Rezoning Transportation Analysis

Petition Number: 2017-190

Date	Description
12-12-17	First Review

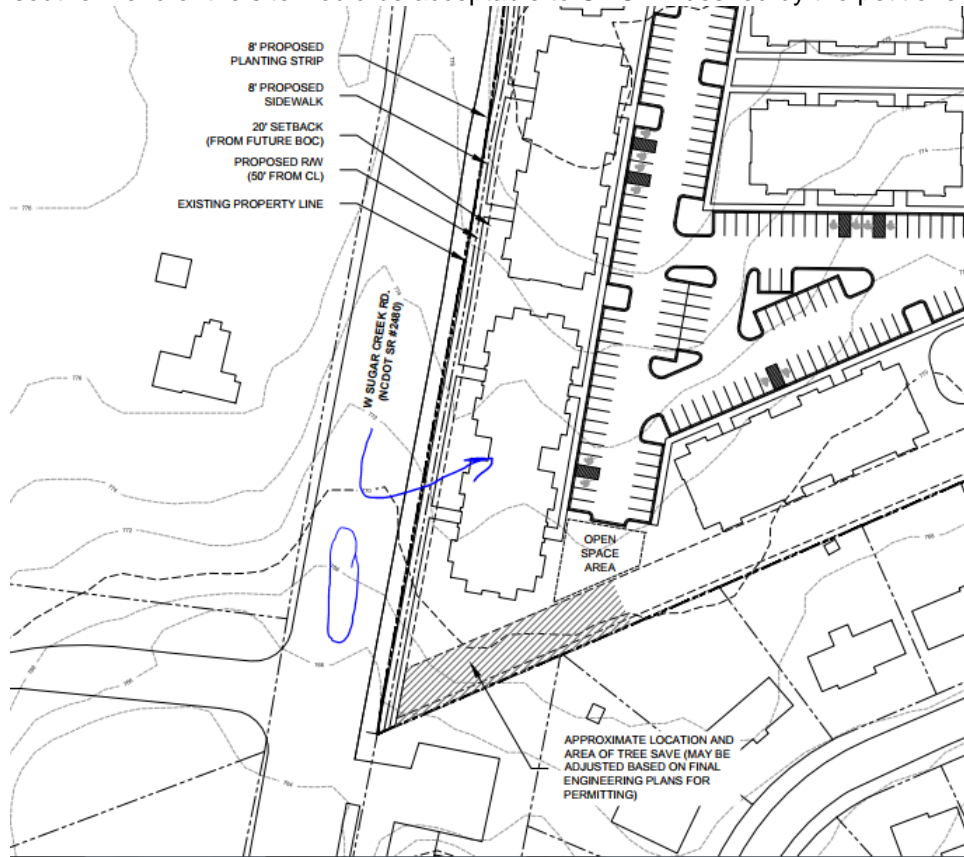
1. **Curbline** The proposed zoning district has a setback measured from back of the existing or proposed future curbline. The location of the future back of curb is 8' behind the existing curb to accommodate a future buffered bike lane.
2. ~~**Traffic Study** A Traffic Impact Study/Transportation Technical Memorandum is not needed for the complete review of this petition.~~
3. The petitioner should revise the conditional note(s) to match site plan 8' planting strip and 8' sidewalk.
4. The petitioner should revise the site plan and conditional note(s) to commit to installation of a pedestrian hybrid beacon and pedestrian refuge at the southern end of site on West Sugar Creek

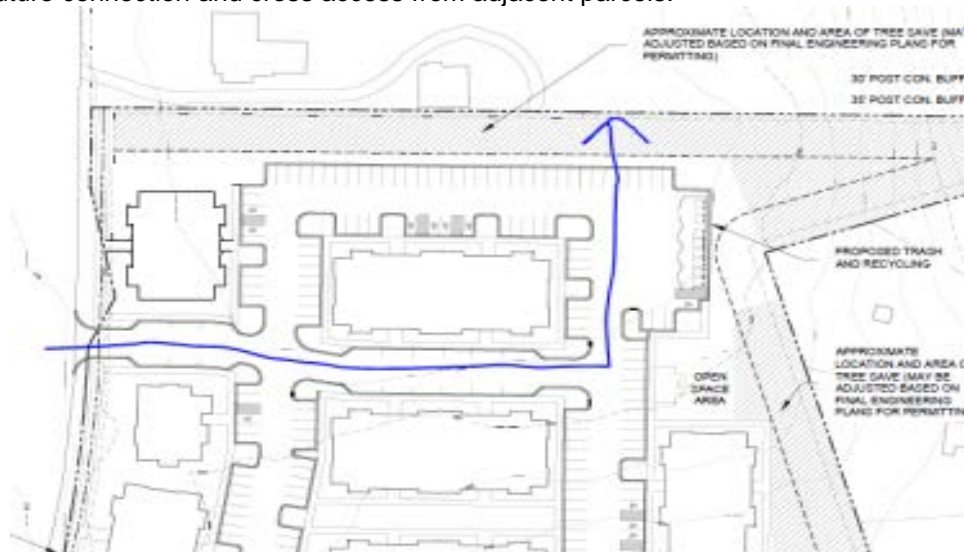
5. The petitioner should revise the site plan and conditional note(s) to revise the drive aisle shown below to allow permanent public access, use a form consistent with a public street section, and create a stub for future connection and cross access from adjacent parcels.

6. The petitioner should revise the site plan and conditional note(s) to remove the on-street parking shown in the first segment of the drive aisle connection to Sugar Creek.
